IDENTIFICATION OF REFRACTORY MATERIAL FAILURES IN CEMENT KILNS CORRECTIONS

CORRECTIONS EXAMINER 1

CORRECTIONS EXAMINER 2

Figure Error! No text of specified style in document.-1. SEM-EDS mapping of the damaged high-alumina powder sample

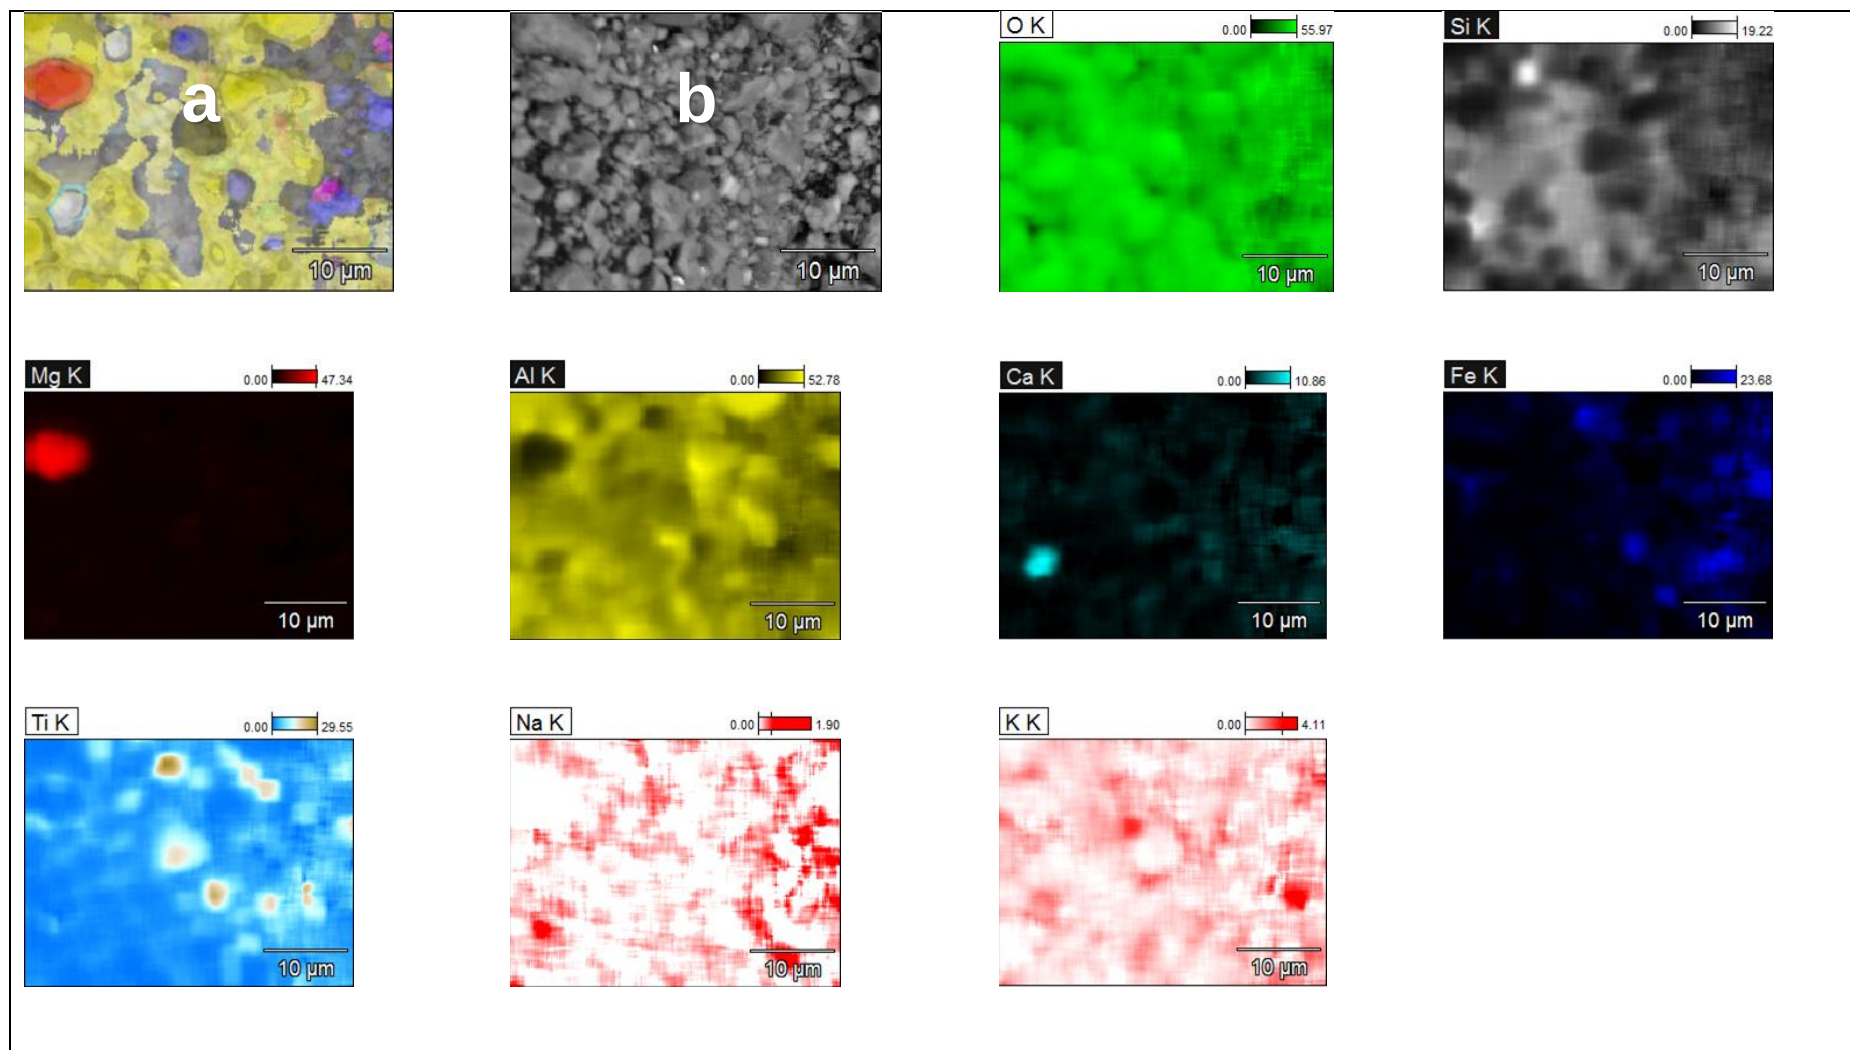
10. p.100. pictures of Figure 5-1. Should be located in the same page (p.100)

p.102. Figure 5-1 is now located in a same page. See the figure below.

Figure Error! No text of specified style in document.-2. X-ray maps of corrosion scale from case 1 kiln

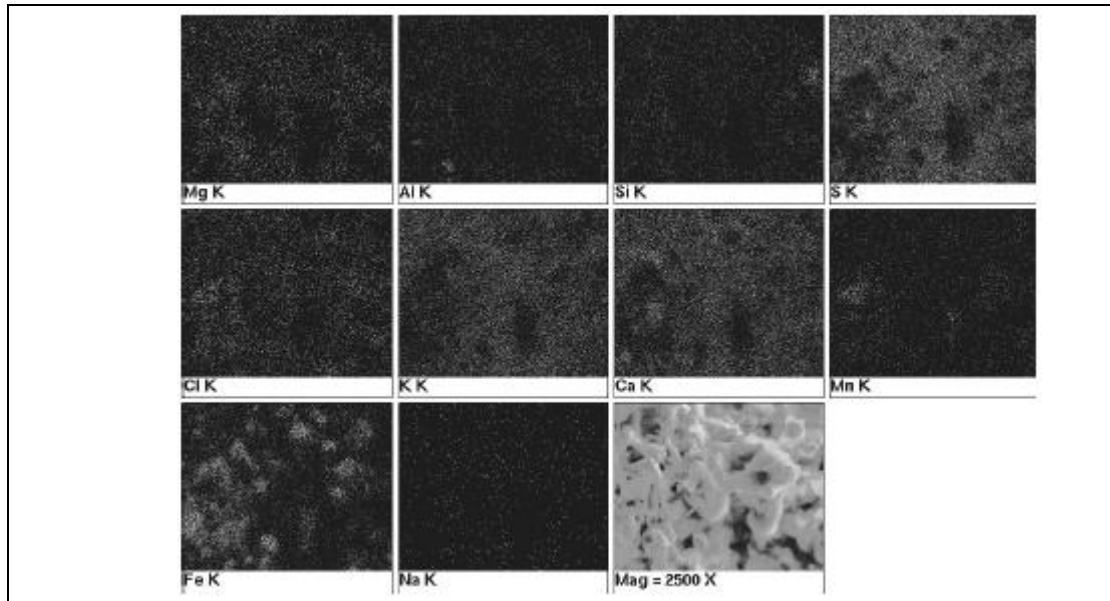
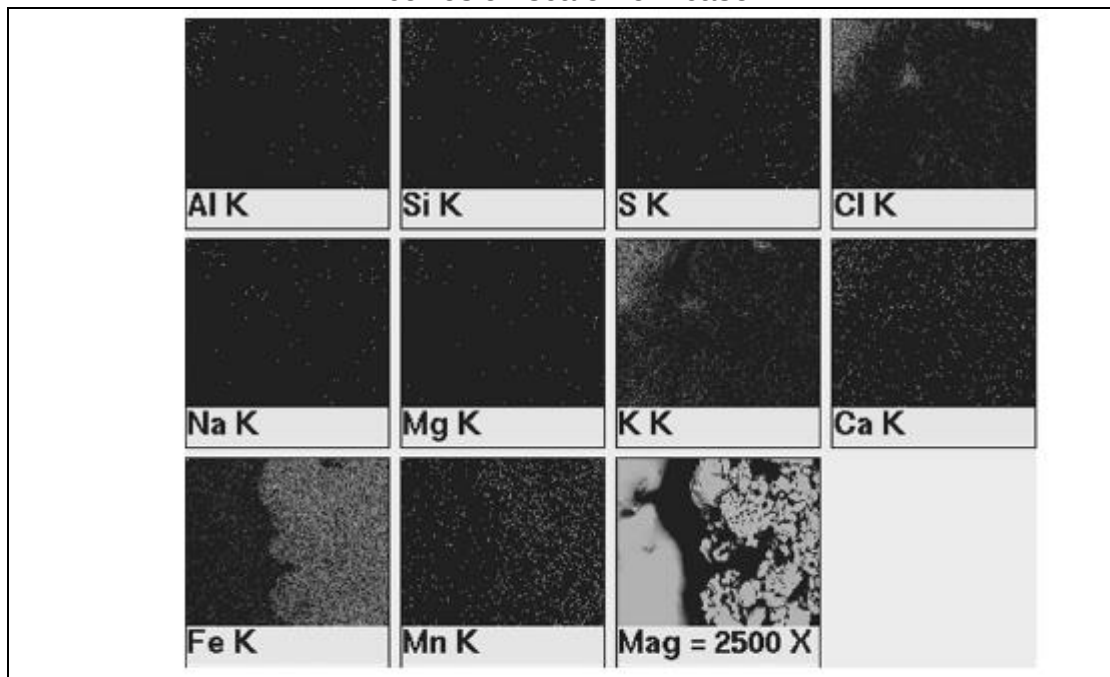
Figure 2-6 and 2-7

Figure 2-6 and 2-7 has been corrected as follows (p.24-25.):

Potgieter et al. (2004) studied high-temperature chemical corrosion in the short and long kilns. The XRF analysis showed higher concentration of sulphur in the short kiln. This indicates that the corrosion that took place was sulphur dominant. The long dry kiln analysis showed a higher concentration of chloride and potassium which points to a chlorine type of attack of the kiln shell. The EDX spectra of each corrosion scale (Figure 2-1 and 2-2) confirmed the analysis from XRF. The X-ray map images of the individual elements indicated high levels of K and Cl with respect to other elements.

Figure 3-3. ASR of the study kiln

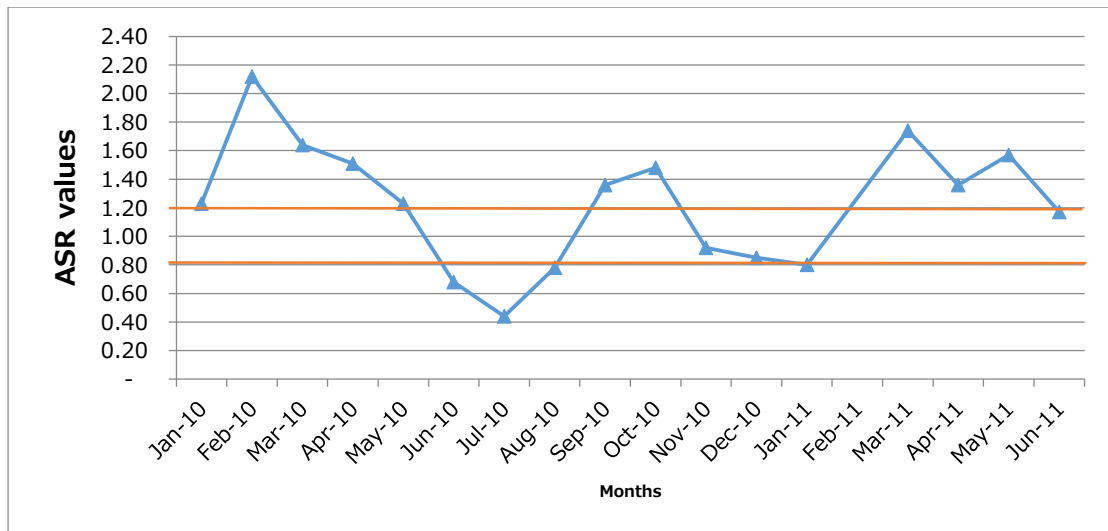
Figure 3-3. The caption is insufficient and it does not agree with the caption in the list of figures.

The caption is corrected and agrees with the caption in the list of figures.

The caption is changed from ASR of the damaged magnesia-spinel lining to [ASR of the study kiln](#) (p.57).

Figure 5-1. SEM-EDS mapping of the damaged high-alumina powder sample

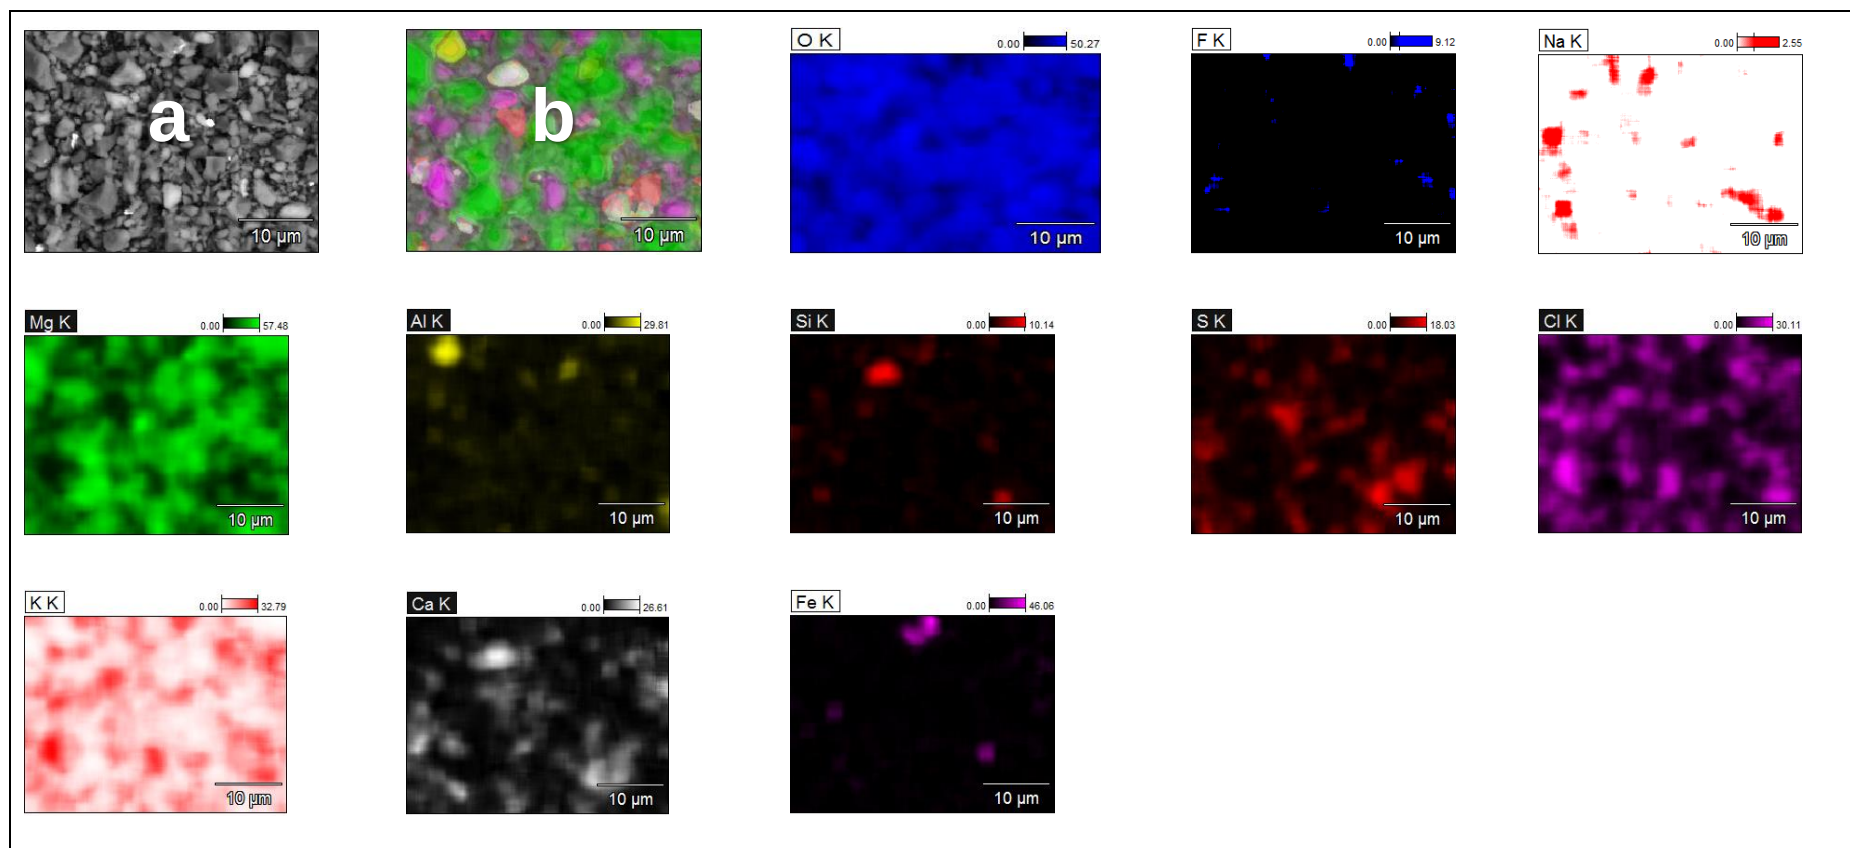
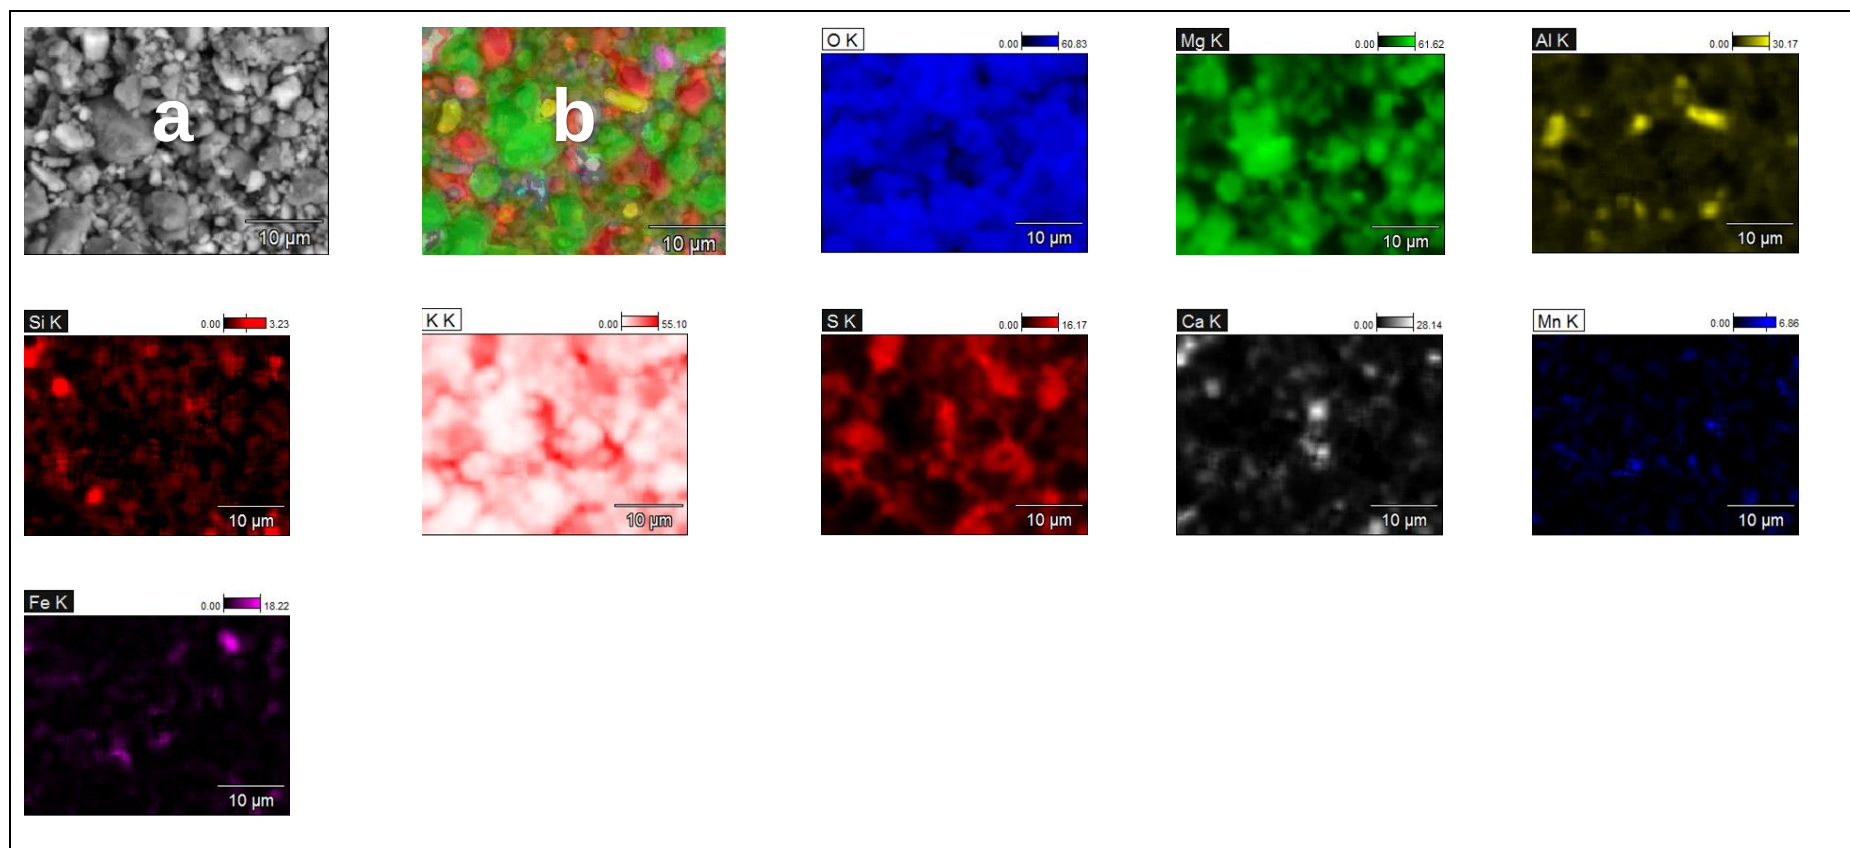
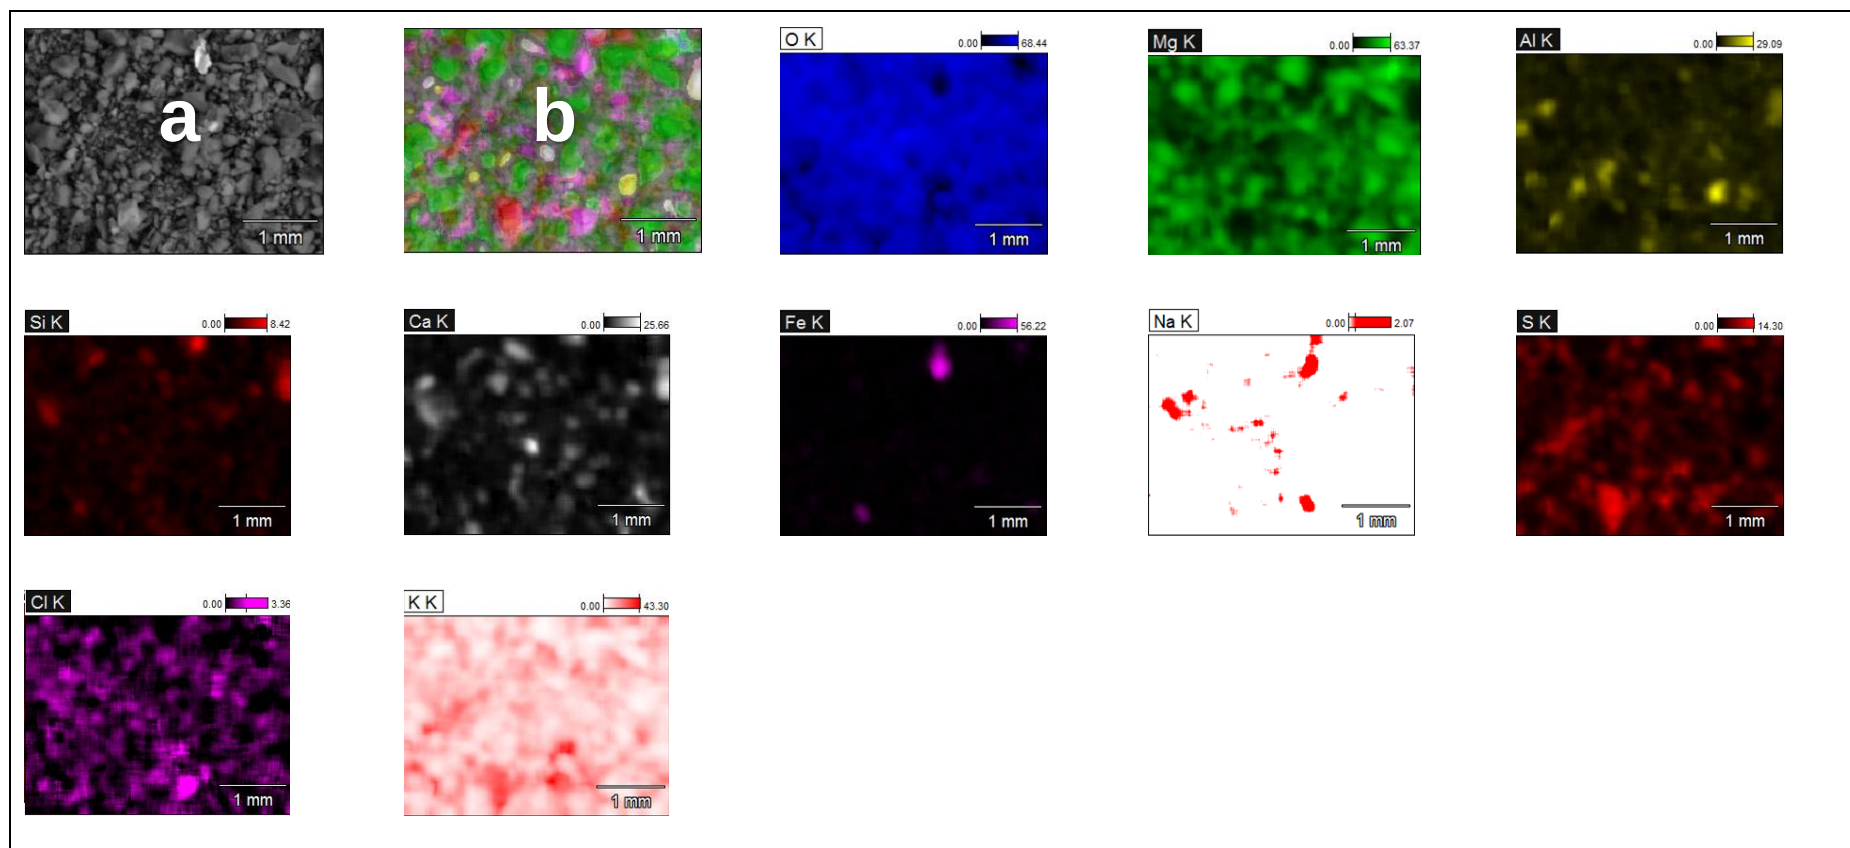
Figure 4-1, 4-2, 5-1. Poor typesetting. Part of the figure appears on a different page from the caption.

The figures have been corrected and now appears in a single page.

Fig 4-1 (p.62), Fig 4-2 (p.63) and Fig 5-1 (p.102).
